MB95330H 系列

8 位微控制器

数据手册

勘误表

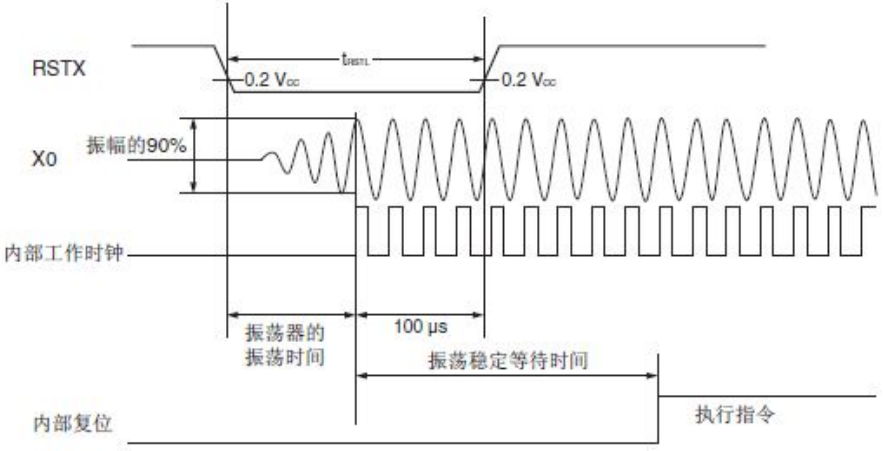
页码	章节	订正内容
37	电气特性	<p>图「■电气特性(3) 外部复位」更正如下</p> <p>(错误)</p> <div><ul style="list-style-type: none">● 正常工作时</div> <p>● 处于停止模式、副时钟模式、副休眠模式、计时模式和上电时</p> <div></div> <p>(订正)</p> <div></div>
